Town of Medway

DESIGN REVIEW COMMITTEE
155 Village Street, Medway MA 02053
(508) 533-3264 • FAX: (508) 321-4988

Meeting Minutes: July 27, 2015
Medway Library, Cole Room

Sign Design Review - Advance Auto Parts:

A1 27" Red Channel Letterset

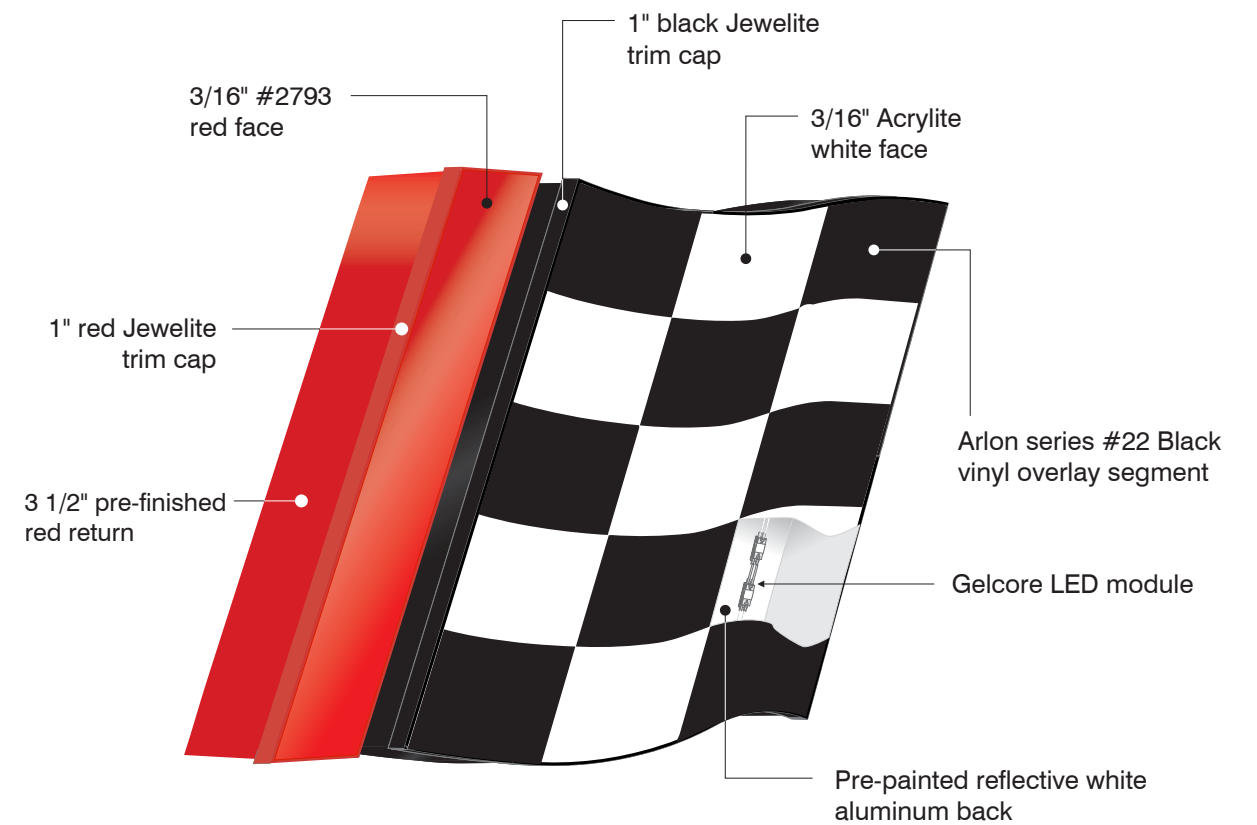
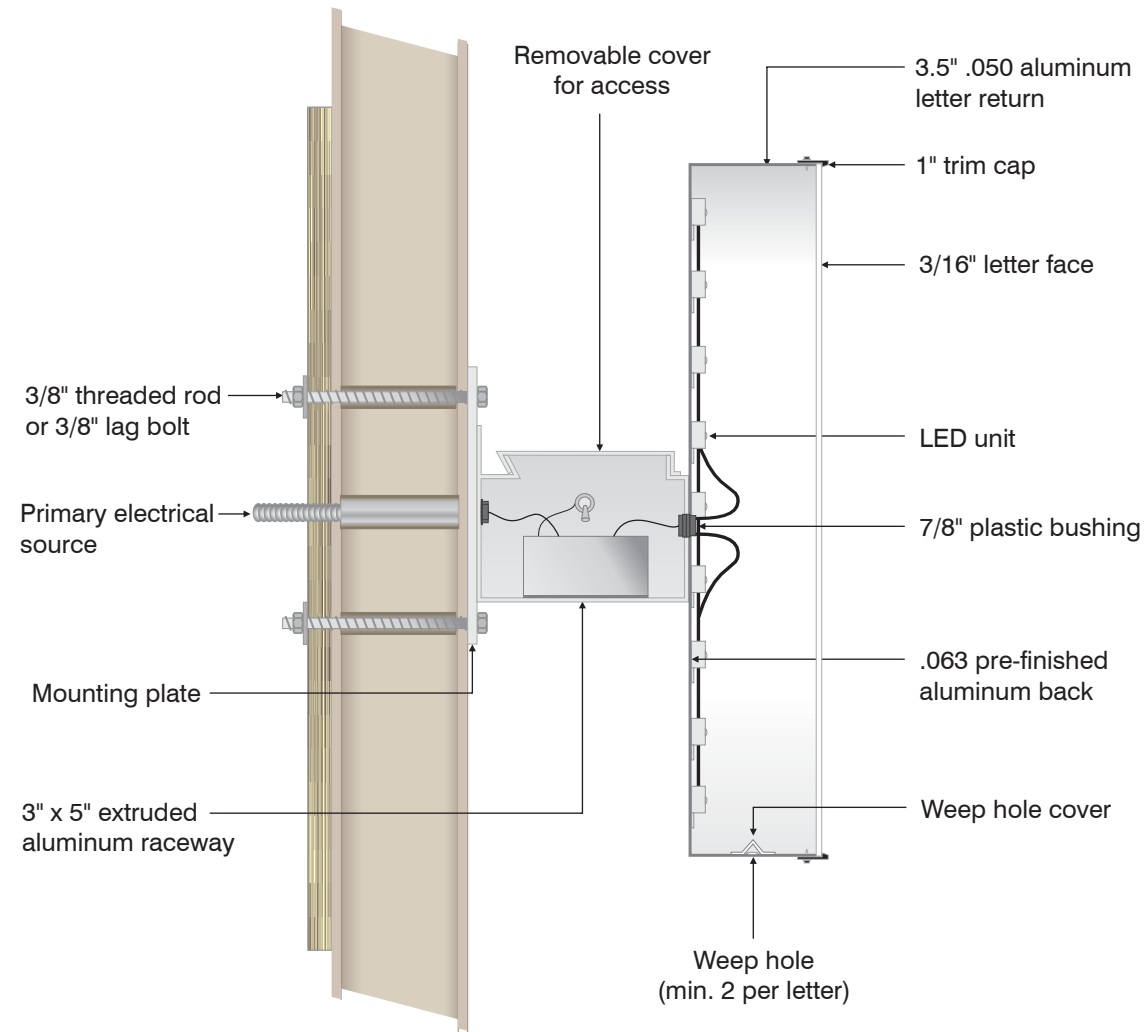
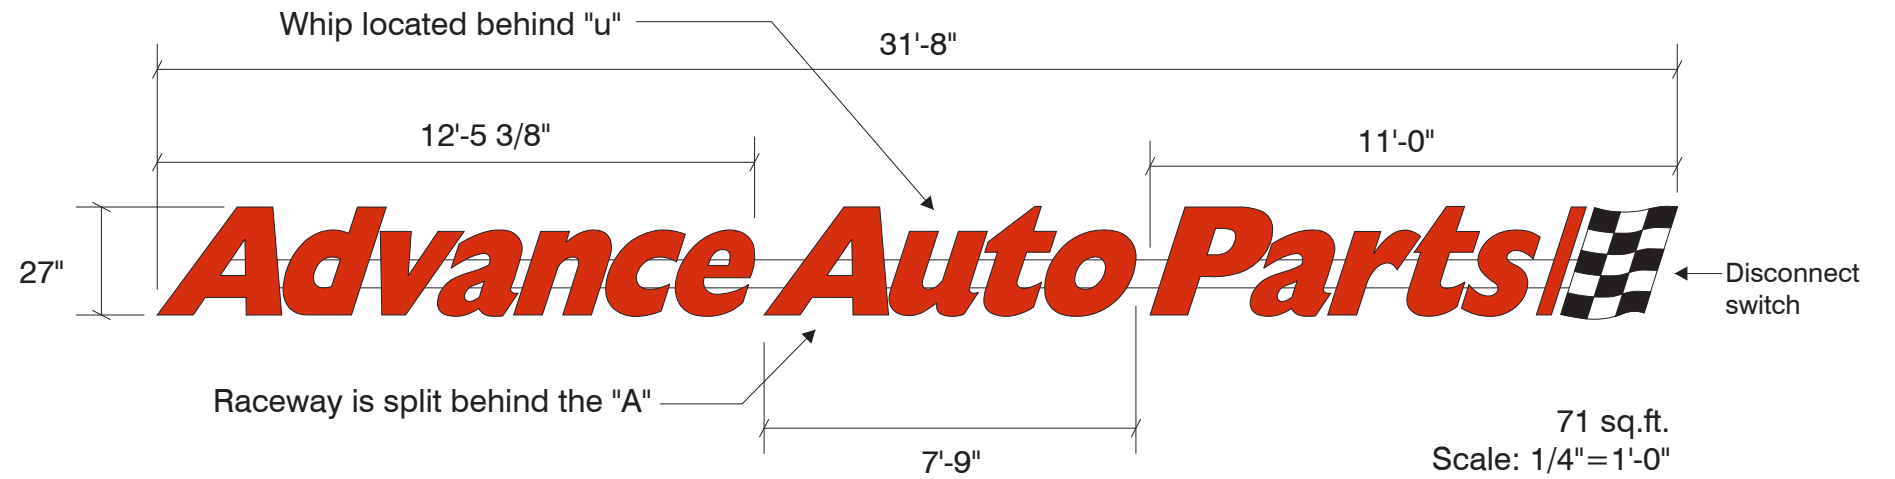
will be red and the flag logo will be black and white. Mr. Schalliol explained that the traditional sign for Advance Auto Parts has a red background with yellow letters but they modified it for this project. The raceway will be the same color as the building. The monument sign will be externally illuminated. The Advance Auto Parts sign panel will have a red background with yellow lettering and the flag will be black and white. The Committee is only approving the sign panel for Advance Auto Parts not the entire monument sign. Planning & Economic Development Coordinator Susy Affleck-Child explained that this monument sign will only contain signs for Buildings A & B. Building C will have its own sign. The Committee made the following recommendations:

- Reduce the size of the lettering and logo on the monument sign panel by 10-15%. It will create more negative space and make the sign easier to read.
- Keep the colors on the wall sign and monument sign consistent. The Committee recommended using red letters and a white background on the monument sign panel to create consistency. Mr. Schalliol said it is unlikely that Advance Auto Parts would change the colors for the monument sign panel as well.
